EAGLE MOUNTAIN CITY
Planning Commission Staff Report
OCTOBER 4TH, 2016

Project: Gotta Dance Studios – Dance Studio
Applicant: Scot Hazard
Request: Preliminary Plat
Type of Action: Action Item

PHASE "A", PLAT 3
CITY CENTER COMMERCIAL
 SUBDIVISION
 EAGLE MOUNTAIN, UTAH COUNTY, UTAH
 SCALE: 1"=30'

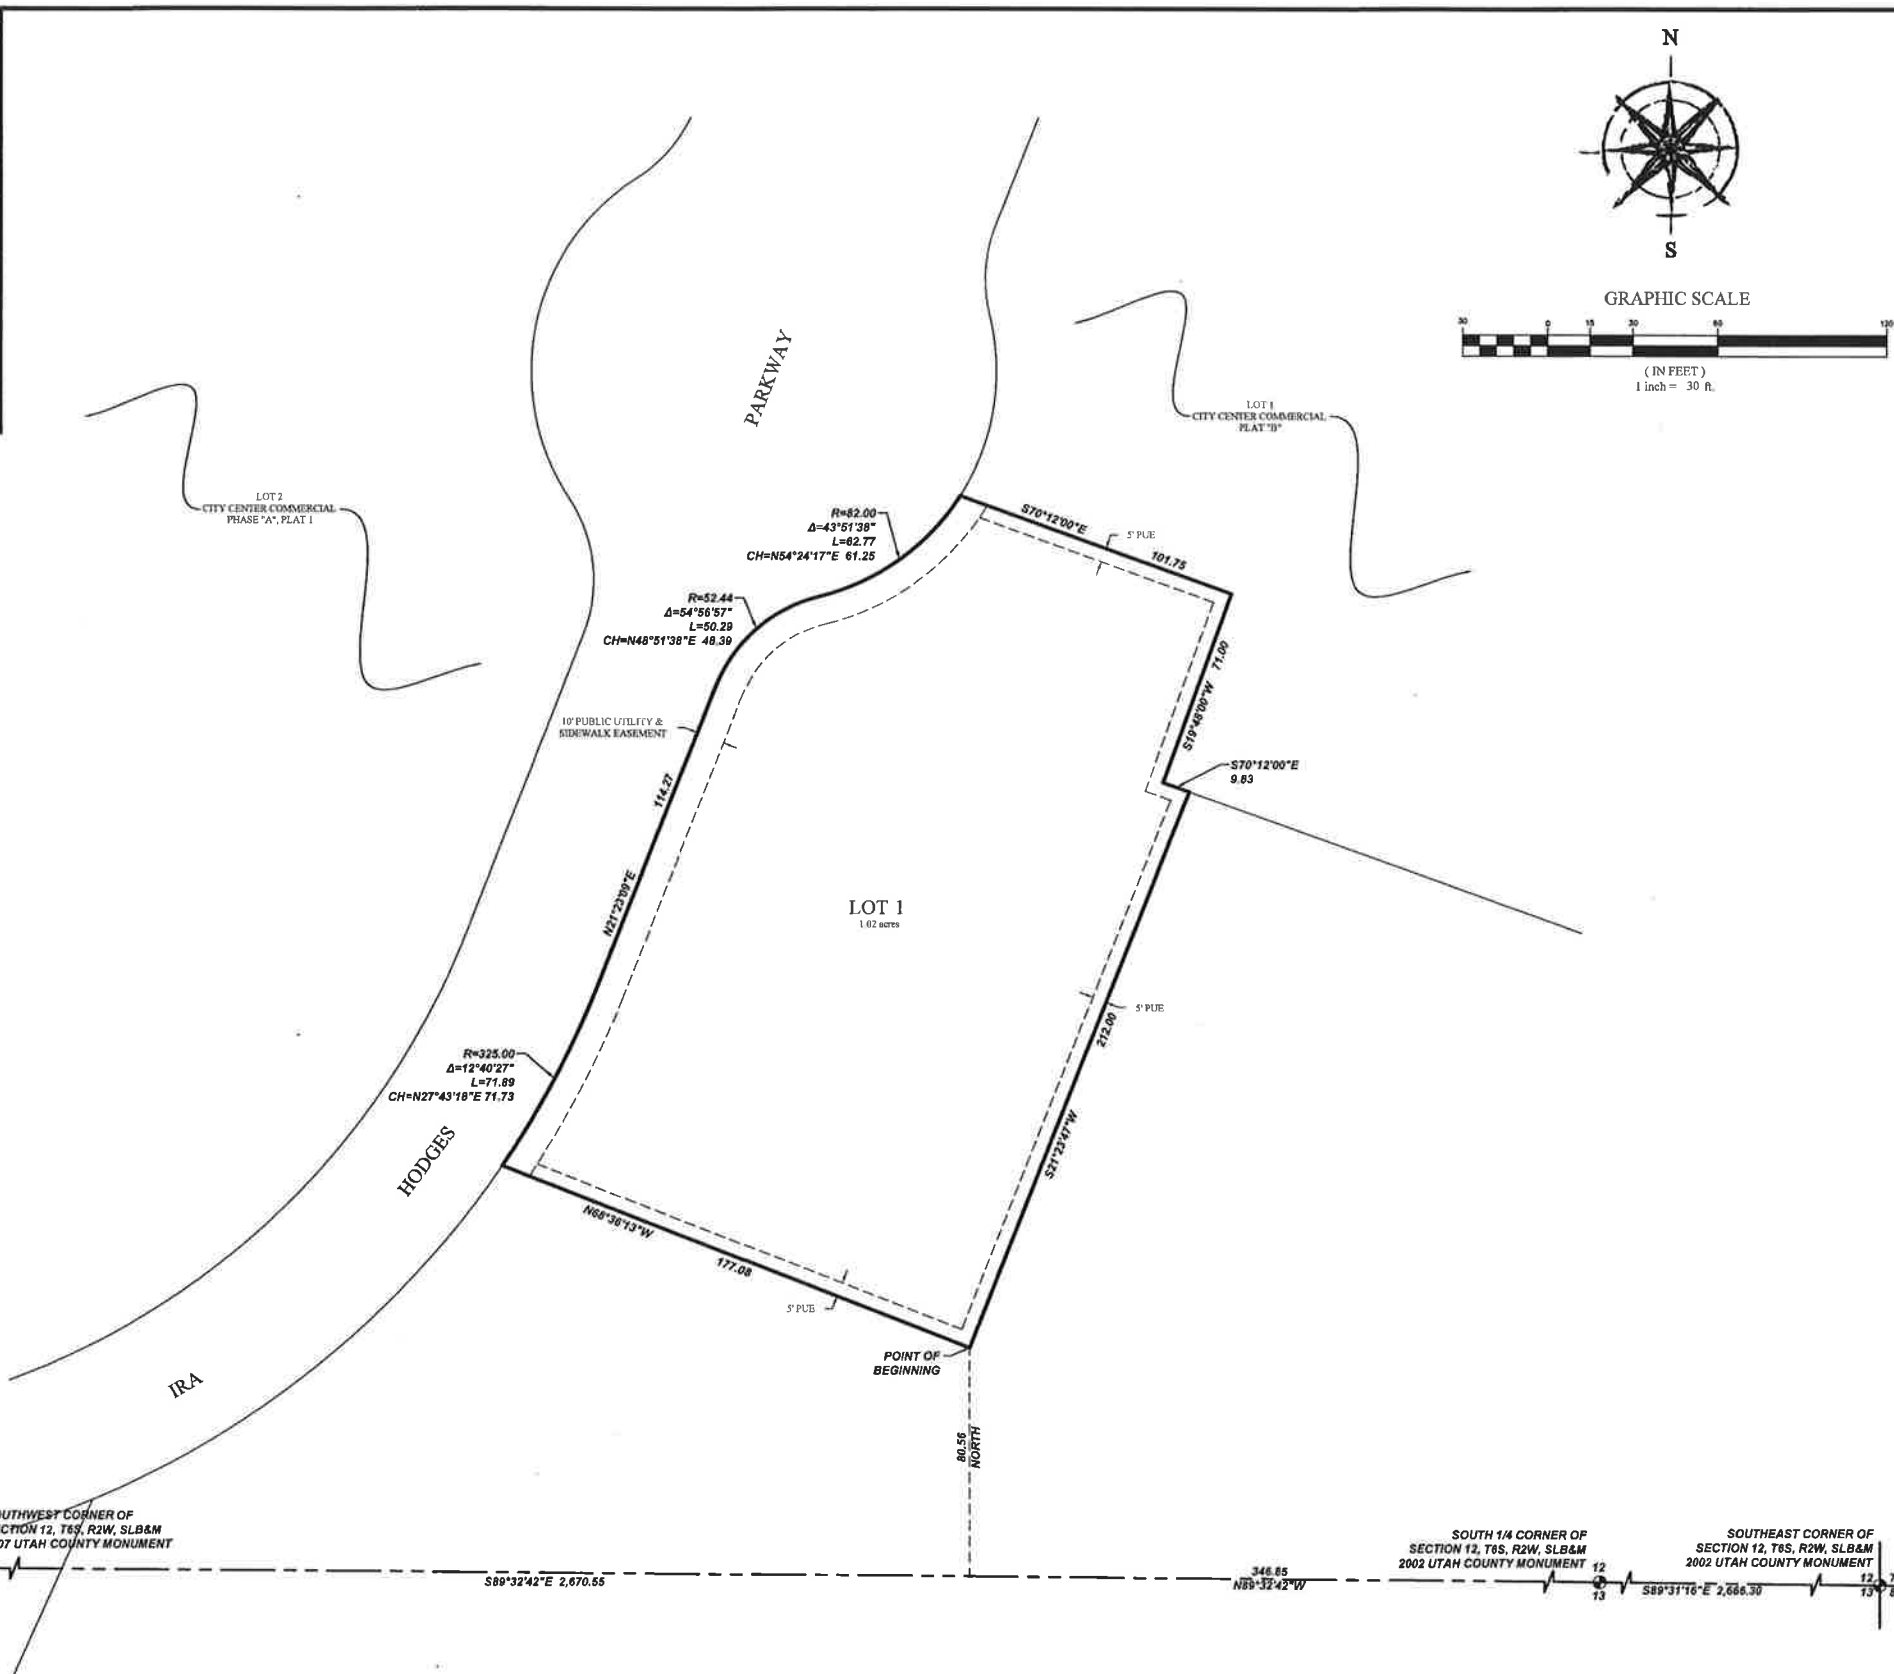
- **Drainage easement:** There is a drainage easement that should be shown on the plat. The easement is to the detention basin to the south of the project. If the easement isn't shown then there should be a note placed on the plat defining the easement.
- **Blanket access easement:** A blanket access easement should be applied to this plat. Since there was no master site plan for this project the easement is needed for future phases of the project.
- **Sidewalk/Trail:** The sidewalk/trail should be dedicated to the City. There is a portion of the sidewalk on the north end that needs to be adjusted, along with the PUE on the east part of the sidewalk. The easement will need to be adjusted slightly.

- 1. The drainage easement to the detention basin is displayed on the plat or a note on the plat defining the easement.*
- 2. A blanket access easement should be placed over the plat for future development.*
- 3. The entire portion of the sidewalk be dedicated to the City*
